METRO PLANNING COMMITTEE OF THE TOWN PLANNING BOARD

MPC Paper No. 8/16

**VARIATION OF APPROVAL CONDITIONS OF THE
PLANNING PERMISSION FOR
THE APPROVED HONG KONG POLYTECHNIC UNIVERSITY (PHASE 8)
DEVELOPMENT AT THE JUNCTION OF CHATHAM ROAD SOUTH AND
PRINCESS MARGARET ROAD, YAU MA TEI, KOWLOON
UNDER APPLICATION NO. A/K2/184-2**

**ACABAS Submission
(Rev. B)**

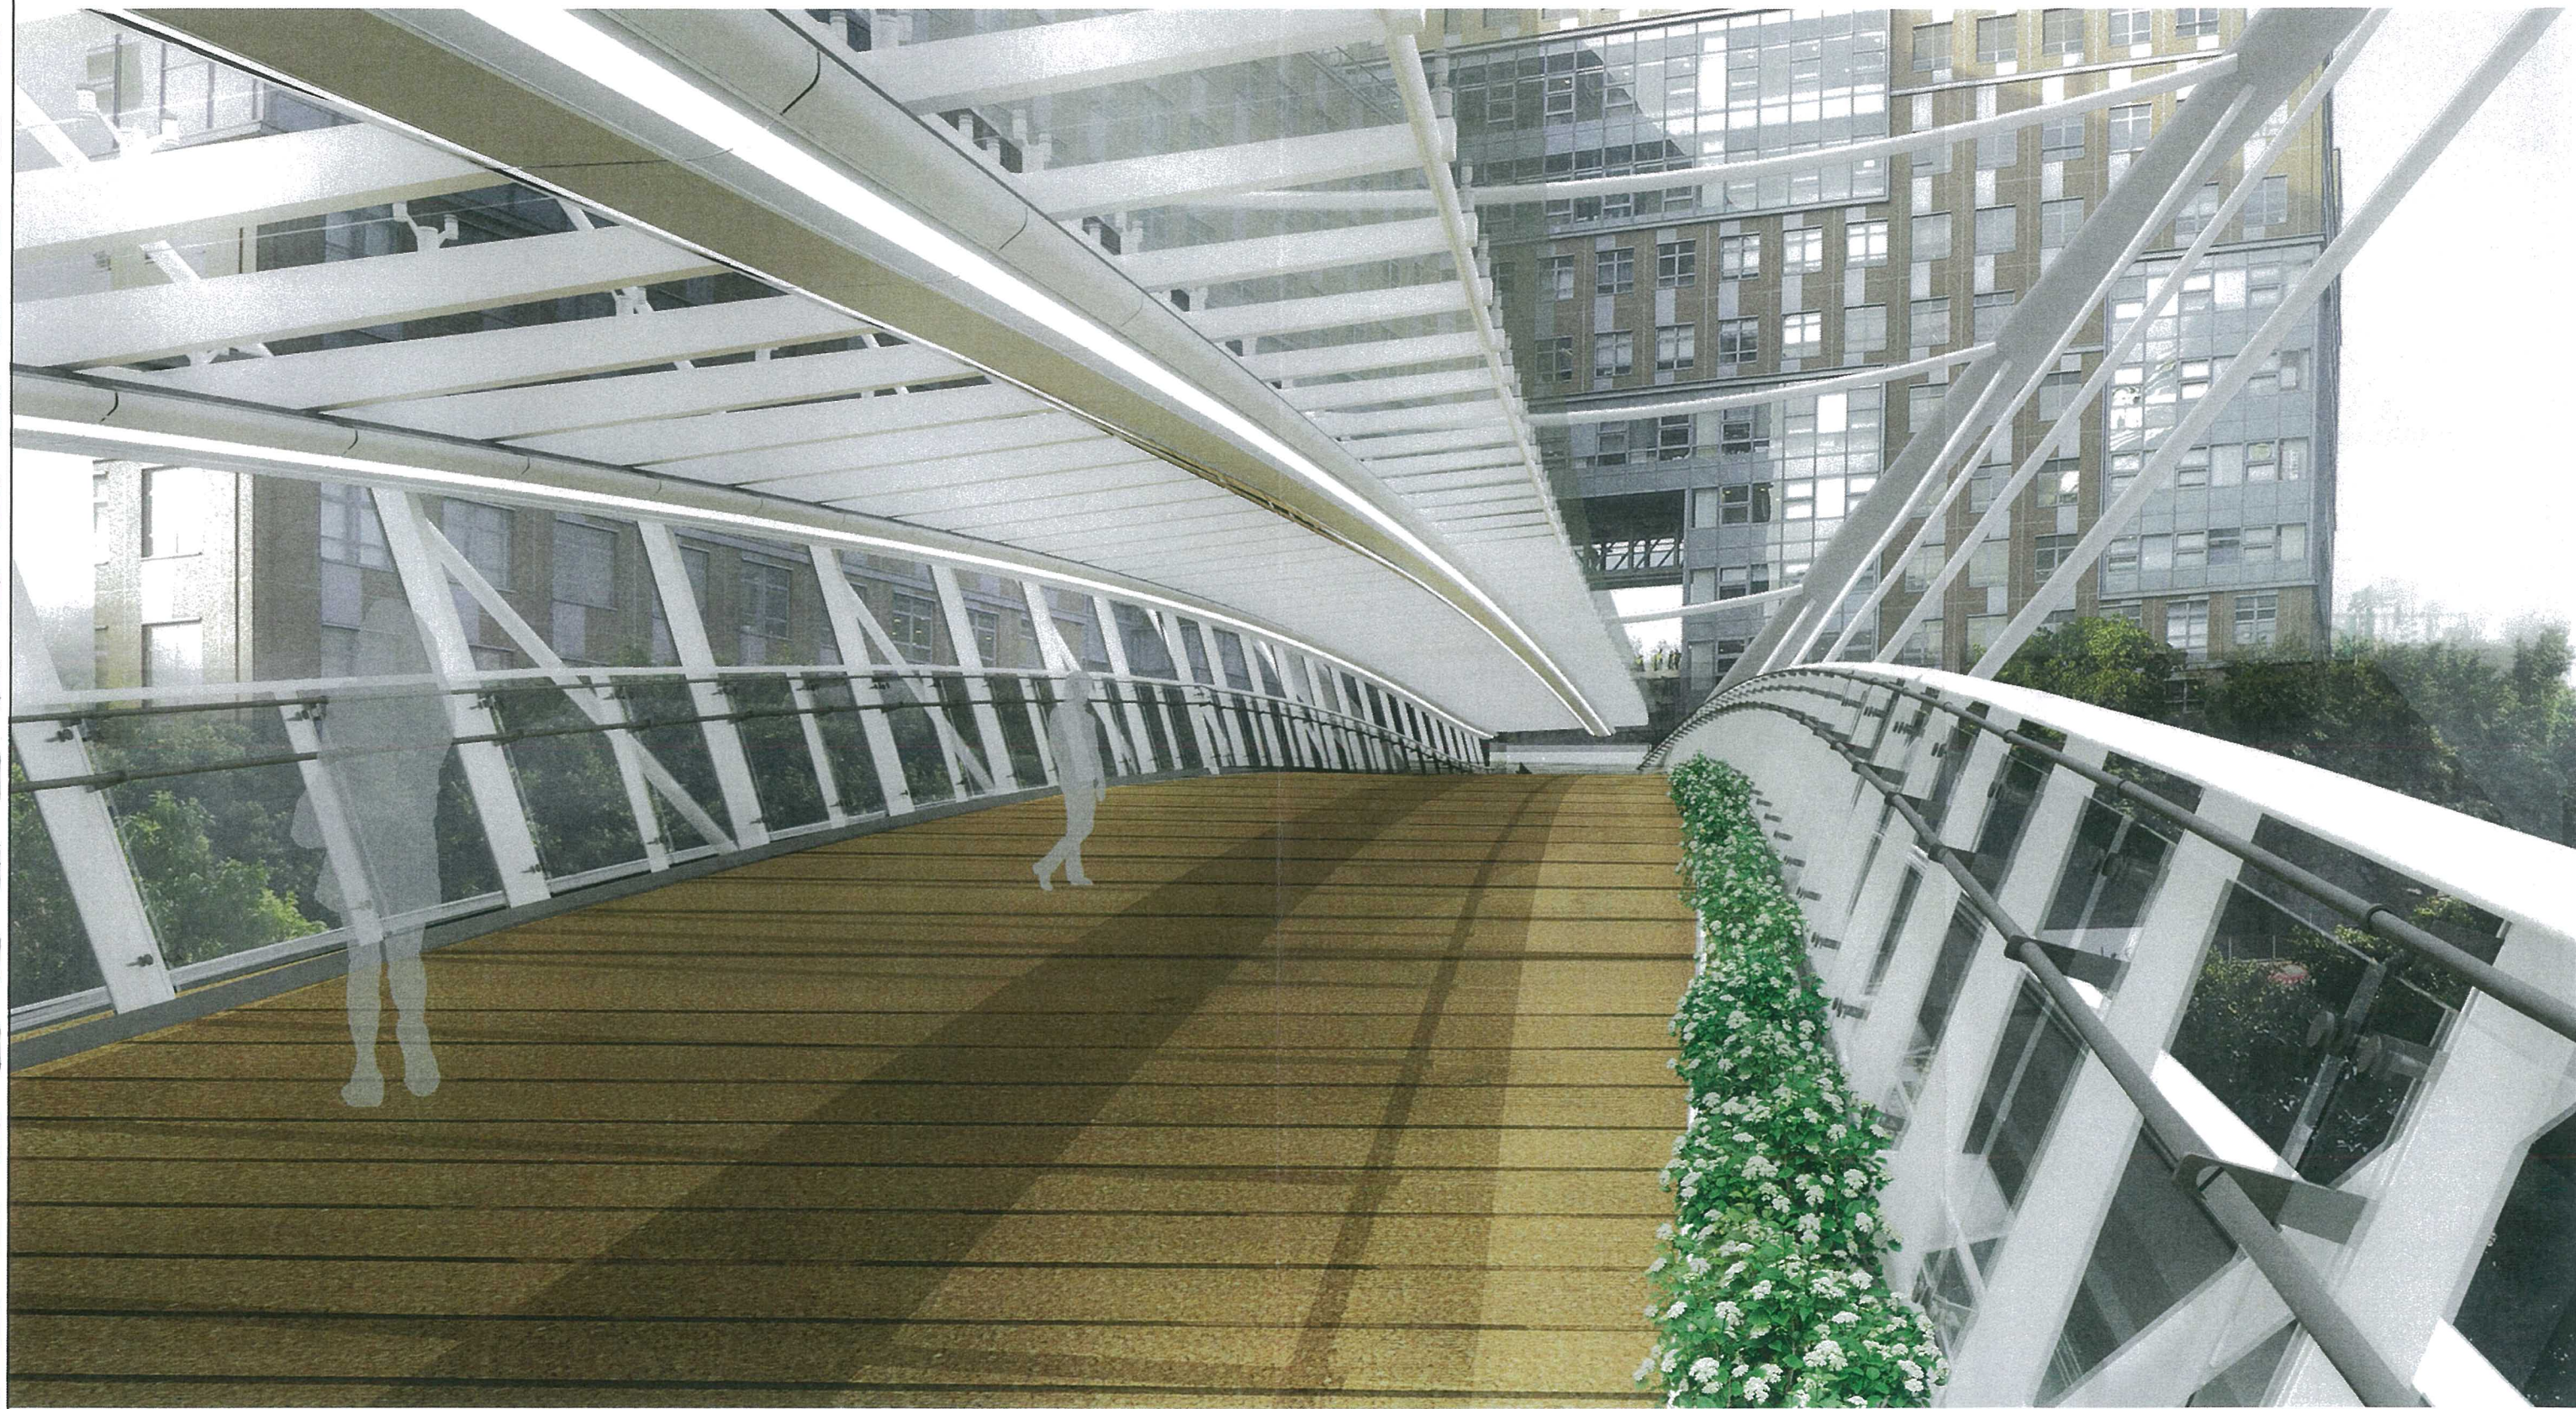
2.	The Committee commented that the level of the highest point of the footbridge deck should be clearly shown.	The level of the highest point of the footbridge had been shown on Section Y-Y. (Drawing A1418/ACABAS/FB-15)

4.	The Committee commented that the proposed arch which landed on deck level at one end while landing on street level at the other end appeared odd, particularly with another column supporting the deck as shown on Section Y-Y on drawing A1418/ACABAS/FB-15. Project team was required to review the structural design for a more balance structural design.	Firstly, the structure imitates a fish flying over the river (road). The footbridge consists of a symmetric arch structure at the main span across Chatham Road South (the Fish Body), then have an immediate support provided by the columns which we call the "Fish Tail"; while the Fish Fins, the last span of the footbridge integrate to Block Z. Secondly, the current location of the arch extension / column supports at Block Z minimised the disturbance to the existing EVA and trees of Block Z, and the compacted size of structural steel members occupy lesser space within the limited working area in Block Z. (Drawing A1418/ACABAS/FB-00C) The structure of the asymmetrical canopy was designed to enrich the pedestrian experience by providing an uncovered portion along the footbridge where pedestrian could fully appreciate the skyline of the neighborhood and the arch structure of the footbridge. The semi-open design also means that the vegetation could receive better sunlight and natural rain water for irrigation. (Drawing A1418/ACABAS/FB-04, 07)

5.	The Committee commented that the Perspective of the proposed internal view as shown on drawing A1418/ACABAS/FB-04 appeared very busy since there were so many elements and features enclosing the footbridge deck. Project team was required to review the structural design for a more simple structure with integrated design.	In response to the Committee's comments, the visual disturbance to the pedestrians was addressed by removing the aluminum fins at the western side. Simple and neat glass balustrade was provided instead. (Drawing A1418/ACABAS/FB-04, 07)

6.	The Committee commented that proposed sun shading grilles along the footbridge made the footbridge look bulky. Project team was required to review the necessity of the sun shading grilles since they would also attract litter and rubbish as the grilles would be very handy.	The sun shading grilles on the western side of the footbridge were removed from the design, a simple, neat glass balustrade was provided instead of the grilles. (Drawing A1418/ACABAS/FB-04, 16)

7.	The Committee commented that the proposed staircases as shown on drawing A1418/ACABAS/FB-05 were not necessity but create funny dead corner at the entrance of footbridge. Project team was required to review the necessity of the staircase and review the design at the entrance from Phase 8 for smooth circulation.	After reviewing the connection at Phase 8, the ramp was widened to provide a spacious path. The steps is retained as an alternative option for non-wheelchair users. The area and extent of the staircase cum ramp were redesigned to provide a more inviting connection. (Drawing A1418/ACABAS/FB-05, 07)

8.	Project team was required to review the alignment of the deck for a smooth alignment at the western end of the footbridge. (Drawing A1418/ACABAS/FB-18)	The profiles at Grid-22 were smoothen. (Drawing A1418/ACABAS/FB-01, 07)	
13 May 2015	21 April 2015	1.	Project team was required to ensure adequate soil depth would be provided to ensure healthy plant growth to achieve the greening provision along the footbridge.	The proposed tray planter system has integrated water retention cell that would enhance the growing conditions. The proposed system was adopted in various government projects. (Some of which were shown in the submission for reference) The suitable species of plants were also listed for reference. (Drawing A1418/ACABAS/FB-17A)	--

2.	The Committee commented that the canopy looked retro-fit structure and should be integrated with the structure of the footbridge. Project team was required to review the structural design for an integrated design.	A cantilever design was adopted for the canopy and the central column had been removed. A higher level of integration between the structure of footbridge and canopy was achieved. (Drawing A1418/ACABAS/FB-05, 16)

3.	The Committee commented that the previous comment 4 (i.e. the Committee commented that the proposed arch which landed on deck level at one end while landing on street level at the other end appeared odd particularly with another column supporting the deck as shown on Section Y-Y on Drawing A1418/ACABAS/FB-15. Project team was required to review the structural design for a more balanced structural design) was not addressed in the latest design. Project team was required to further review the structural integrity of the design, particularly the structural landing at street level, for a more balanced structural design.	The pier of the footbridge at Block Z had been revised. The previous design of steel supports were replaced by an R.C. support. (Drawing A1418/ACABAS/FB-05A, 13A, 15)

4.	Project team was required to provide photomontage showing view from the EVA towards the structural landing at the street level.	A perspective of footbridge from the EVA was provided for the Committee's review. (Drawing A1418/ACABAS/FB-05A)

- (i) The proposed tray planter system integrated water retention cell that would enhance the growing conditions. The proposed system was adopted in various government projects. The suitable species of plants were also listed for reference. (Drawing A1418/ACABAS/FB-17A)

- (ii) The central column had been removed. The posts of the canopy were integrated into the structural grid of the bridge deck for a higher level of integration between the structure of footbridge and canopy. (Drawing A1418/ACABAS/FB-05 & 16)

- (iii) After further review, the 2 pairs of the steel support were found most suitable to suit the site condition (i.e. existing trees and E.V.A.) The front pair of steel support of the bridge at Block Z was painted in a darker colour to differentiate from the other supports. The profiled corbel had been refined at the connection to Block X to achieve a more balanced design. (Drawing A1418/ACABAS/FB-05A & 15)

- (iv) A perspective of footbridge from the EVA was provided. (Drawing A1418/ACABAS/FB-05A)
